**Subject:** RE: Summary of Conference Call

**Site Plan and Proposed Sample Locations** 39155 and 39183 State Street

Fremont, California

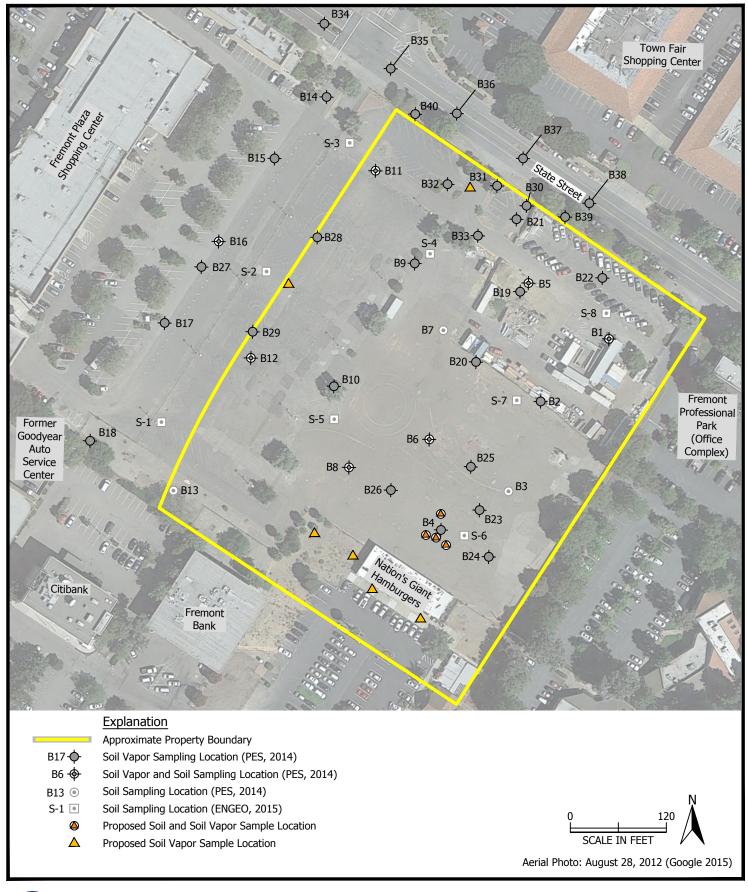
I / ACEH is not aware of the thinking behind the addition of the four soil vapor points, other than the addition of the area to the area of investigation, but added data is beneficial for understanding a site. With that in mind, is there sufficient data in the relatively open area rimmed by B13, B12, S5, and B8 and the western most new location?

Thanks for the summary. The reasoning appears sound. In regards to Buildings A & B, I would request the soil type for the entire 12 foot excavation depth be considered, and not just the upper 5 feet. One item that did not come up and I didn't think to request in the letter, is to request that all bores be logged. They always provide useful information and is a standard ACEH request.

- 1) The three proposed soil/soil vapor borings surrounding boring B4 will be moved in so that they are spaced at a distance of 20 feet from boring B4.

- 2) PES will collect a soil vapor sample from depths of 5 feet and 10 feet below ground surface adjacent to boring B4.
- 3) PES will ensure that enough soil sample is collected from each location to run a duplicate sample to be analyzed for total petroleum hydrocarbons (TPH) quantified as diesel and motor oil without silica gel cleanup.

- 5) PES will add two new borings within the footprint of the planned parking garage on the northwestern portion of the site. One location will be located between the prior borings B31 and B32. The second boring will located between prior borings B28 and B29. Each boring will be advanced to approximately 13 feet below ground surface to collect a soil vapor sample.

Mark – we are pushing the limits for what we can accomplish in one day of work. Any additional sampling would push us in to another full day. I suggest we: 1) drop one of the four soil gas locations around the Nation's building and move it to your area of interest; and 2) move the remaining three locations at the sliver parcel to cover the area equally. I will follow-up with a revised map.

Attached please find a revised Plate 2 that shows the new boring locations described above.
